Access Compliance Report

Public Rights-of-Way

(Curb Ramps)

Intersection ID: 11463	Main Street: ABERDEEN_ST	Cross Street: WHITEHALL_DR	Location:	W
ADA ID: 0C517BA20370	Ramp Type: Perp	Initial Pass/Fail: Fail	Overall Compliance: No	Severity Score: 25
Codes/Mitigation Info/Possible Solution		Field Measurements/Component Compliance

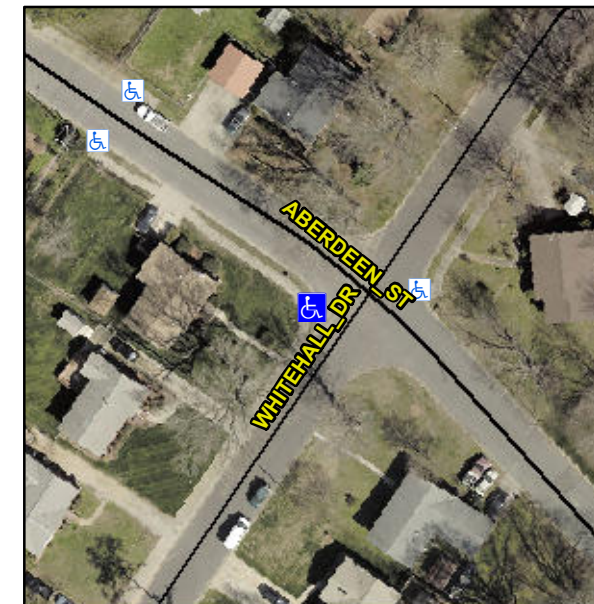
Not Found, R304.5.3

Compliance	Description	Data	Compliance	Description	Data
N/A	Ramp Length (in)	48.0	Yes	Ramp Slope (%)	6.9
Yes	Ramp Width (in)	48.0	No	Ramp XSlope (%)	8.5
N/A	Flare Type LT	N/A	N/A	Flare Type RT	N/A
N/A	Flare Slope LT (%)	N/A	N/A	Flare Slope RT (%)	N/A
N/A	Flare Traversable LT?	N/A	N/A	Flare Traversable RT?	N/A
N/A	Landing Length (in)	N/A	N/A	DWS Provided?	N/A
N/A	Landing Width (in)	N/A	N/A	DWS Contrast?	N/A
N/A	Landing Slope (%)	N/A	N/A	DWS Length (in)	N/A
N/A	Landing X Slope (%)	N/A	N/A	DWS Full Width?	N/A
N/A	Landing Curb? (Y/N)	N/A	N/A	DWS Offset (in)	N/A
N/A	Shared Landing?	N/A			
N/A	Gutter Ponding?	N/A	N/A	Gutter Slope (%)	N/A
N/A	Gutter Lip Ht (in)	N/A	N/A	Gutter X Slope (%)	N/A
N/A	Painted X Walk1?	No	N/A	Painted X Walk2?	N/A
	X Walk 1 Direction	To SE		X Walk 2 Direction	N/A
N/A	X Walk 1 Width (in)	N/A	N/A	X Walk 2 Width (in)	N/A
	X Walk 1 Slope (%)	1.1		X Walk 2 Slope (%)	N/A
	X Walk 1 X Slope (%)	7.1		X Walk 2 X Slope (%)	N/A

Remove & Replace Entire Ramp.
